From: Chief Officer, Environment & Technical **To:** Chief Officer Planning & Regulatory
Our Ref: P/2019/0525 **Your Ref:** P/2019/0525
Date: 16th April 2020

Location: O. S Grid Ref: 3346 5622 Land at Home Farm, Gresford Road, Llay
Development: Erection of foodstore (use class A1), car parking, access and landscaping

Project:	Aldi, Crown Crossroads, Llay	Your reference:	
Our reference:	400757 WA01	Date:	4 th March 2020
Prepared by:	Bev Price	Checked by:	Craig Hunter
Approved by:	Paul Walton		
Subject:	REVIEW OF TA SUBMITTED TO WREXHAM COUNCIL BY CAMERON ROSE ASSOCIATES ON BEHALF OF ALDI STORES LTD

Project:	Aldi, Crown Crossroads, Llay		
Our reference:	400757 WA01 02	Your reference:	
Prepared by:	Paul Walton	Date:	27 th March 2020
Approved by:	Sion Williams	Checked by:	Bev Price
Subject:	ROAD SAFETY REVIEW OF TA SUBMITTED TO WREXHAM COUNCIL BY CAMERON ROSE ASSOCIATES ON BEHALF OF ALDI STORES LTD

Figure 2.1: Annual Traffic for Wrexham by vehicle type.

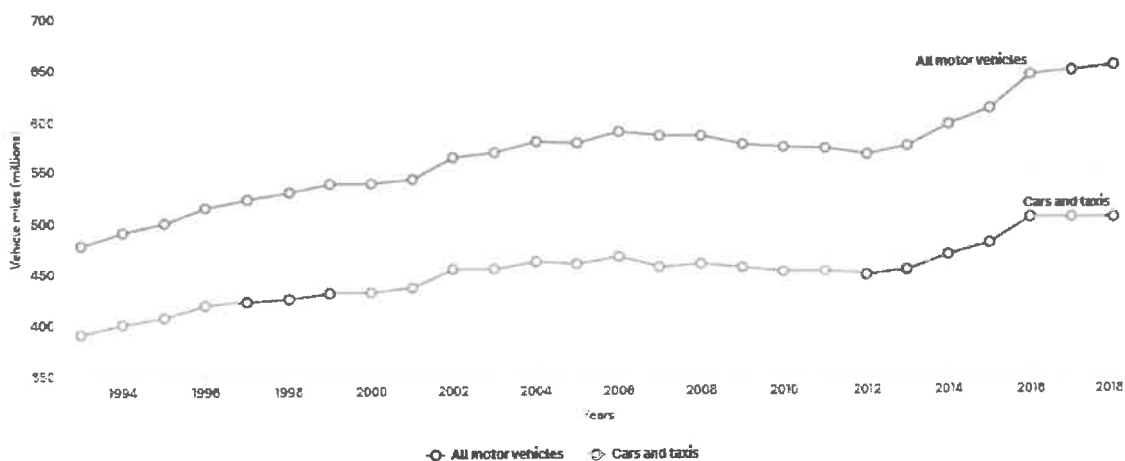
In order to consider the validity of the flows, Mott MacDonald have interrogated statistics held on the Department for Transport website; Figure 2.1 below shows the change in traffic flow in Wrexham and indicates that there has been a reduction in traffic growth and a levelling off of cars and taxi trips since 2016.

Given that the traffic flows observed at the three locations do not all show the same change in flow between 2014 and 2019 it is perhaps more pertinent to refer to the graph provided for Wrexham as a whole which does suggest that traffic growth has slowed down in recent years. Without contradictory evidence to suggest that the survey data is incorrect or that the day of the survey was not a neutral day there can be no reason to question its validity. A manual check of the survey could be carried out to provide further reassurance, if the video survey data is made available by the survey company.

Figure 2.1: Proposed Aldi Store, Llay, Wrexham. Site Plan

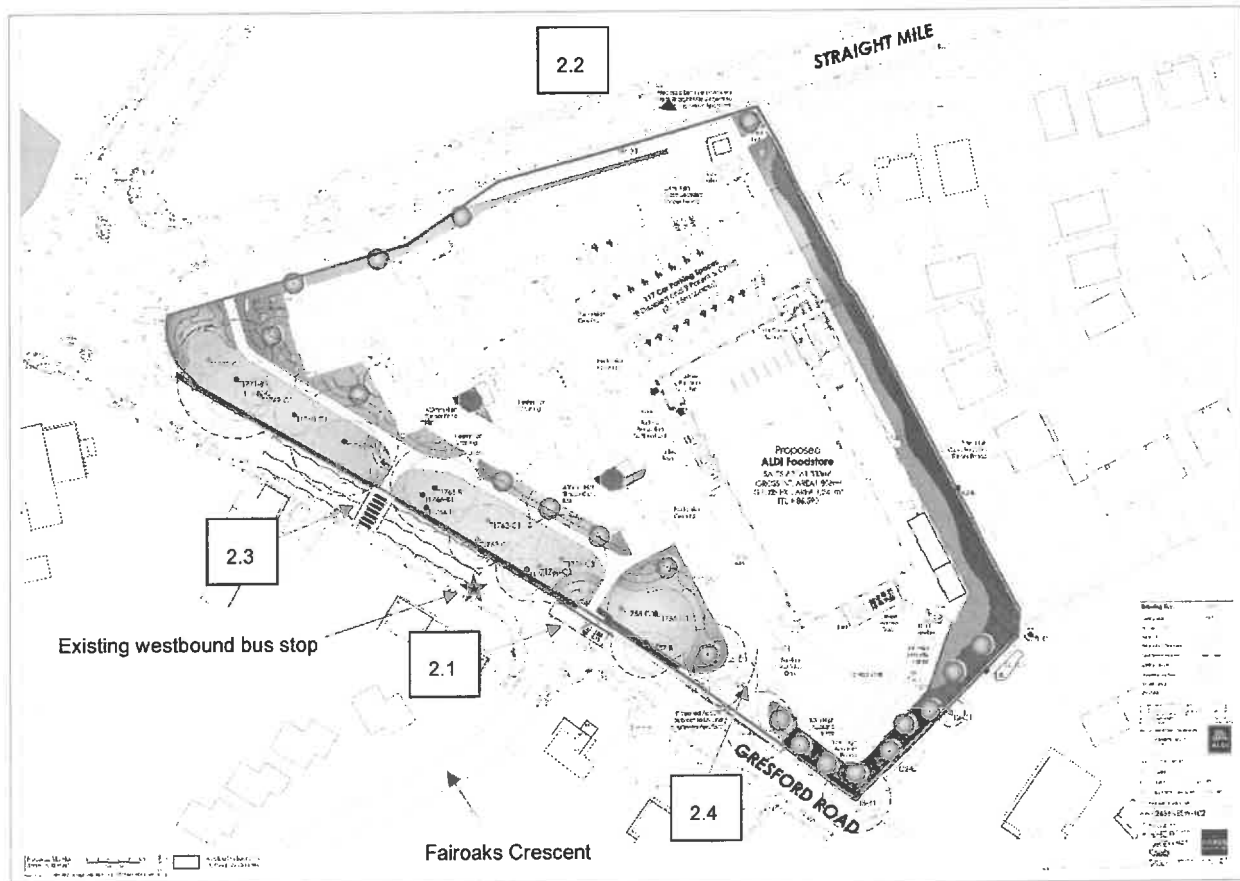
The assessment was based on application drawing number 2636NESW-102 Rev D, as shown in Figure 2.1. In addition, a site assessment was undertaken on Wednesday 26th February 2020 with an officer from Wrexham County Borough Council also in attendance. Points considered have been highlighted on the plan with respective paragraph numbers.

The scheme drawing indicates a proposed bus stop on Gresford Road opposite the existing junction with Fair Oaks Crescent. It is not normally good practice to site bus stops in such locations where turning conflicts may arise between vehicles turning right from the minor road and a stationary bus. However, it is clear from the scheme proposals that an alternative site for the bus stop is limited within the vicinity of the store.

Turning movements from the minor road are expected to be relatively low and although no bus frequency figures are known they too are expected to be low. The likelihood of turning conflicts from this junction are therefore considered to be low. Should a motorist waiting to turn right from Fair Oaks Crescent be impacted

by a stationary bus, then it would be expected that the driver would use their own judgement as to when there was a safe opportunity to move and this may involve waiting for the bus to move first.

It is also worth noting that an existing bus stop flag is positioned on a lighting column to the west of Fair Oaks Crescent (see Figure 2.1) serving westbound movements. It appears that this location is acceptable with regard to the proximity of the proposed zebra crossing and start point of associated zig-zag markings. No existing bus stop is located serving eastbound movements in the vicinity of the store.

This road is currently subject to a 50mph speed limit, with the speed limit dropping to 40mph prior to the signal-controlled junction with Gresford Road. It is noted that the proposed site access into the store from Straight Mile is left-in only with no egress movements permitted. It is also noted that the drawing highlights this access is 'Subject to LA and Highways Approval'.

Based on the design standard CD123 from the Design Manual for Roads and Bridges covering 'Geometric design of at-grade priority and signal-controlled junctions' for roads with a speed limit greater than 85kph a nearside diverging taper or auxiliary lane should generally be provided. This is dependent on predicted major road flows and left turning flows into the minor road. Since the existing 50mph speed limit on Straight Mile is below this (80kph) then it could be argued that a nearside diverging taper is not required. However, the good forward visibility on Straight Mile and potential for greater speeds could result in shunt type

collisions as vehicles unexpectedly slow down to enter the store access. The access currently proposed in the drawing has tight turning radii which may exacerbate this issue.

A zebra crossing is proposed on Gresford Road to the North-West of Fair Oaks Crescent connecting to a pedestrian access to the store. A route is then provided through the car parking area to the store entrance which is positioned on the north side of the store footprint.

From the site inspection and a review of alternative locations for the zebra crossing it was considered that the current position is the most suitable. It is located away from driveways and access points and will draw people towards the main pedestrian route into the store. Alternative locations for the crossing are limited by existing driveways and the presence of Fair Oaks Crescent.

One point of note is the need to ensure adequate visibility is provided for pedestrians when waiting to use the zebra crossing on the northern side. A gap is to be created within existing trees to create a pedestrian route into the store, however, vegetation should also be cut back as required and maintained on a regular basis on the northern side of Gresford Road in the vicinity of the crossing. Tactile paving should also be provided at the zebra crossing.

The proposed service yard to the store is located in the south-eastern corner close to the main vehicular entrance. Although some swept path movements for the service vehicle are indicated on the scheme drawing there is nothing shown for left turn movements out of the site. The close proximity of the service yard to the main entrance will result in restrictive space for a service vehicle to undertake this manoeuvre. Further evidence should be provided to indicate the suitability of space to enable all turning movements to be provided safely without conflict with other vehicles and pedestrians using the footways.

Ideally, the service yard would be better placed away from its proposed location close to the main store entrance to avoid conflicts between service vehicles and customer vehicles. However, it is expected that service vehicle trips will be at non-peak times thus avoiding conflicts with busy shopping trips. It is recommended that a condition is included that the developer ensures all service trips are at times when the store is closed to avoid any vehicular conflicts.

Should the speed limit remain as 50mph then it is recommended that a nearside diverging lane is provided to the store access in accordance with CD123.

- The proposed bus stop on Gresford Road is not ideally positioned opposite the junction with Fair Oaks Crescent. However, there are limited alternative locations for this stop within close proximity of the store and the likelihood of turning related conflicts is expected to be minimal;

- For the proposed store access from Straight Mile it is recommended that the speed limit is reduced to enable slower approach speeds to this entrance in accordance with the DMRB standard CD123 and avoid the potential for shunt type collisions to occur.

- Should the existing speed limit of 50mph remain on Straight Mile then a nearside diverge taper should be provided to the store access in accordance with CD123.

- The zebra crossing proposed on Gresford Road is considered to be in an acceptable location. However, it is recommended that existing vegetation on the northern side of the crossing point is cut back to provide adequate visibility for pedestrians;

- Vehicular tracking should be provided to indicate sufficient turning space is provided for service vehicles when exiting the store, especially when turning left; and

- A condition should be provided to the store operation to ensure service vehicles access and egress the site outside of store opening times to avoid vehicular conflicts.
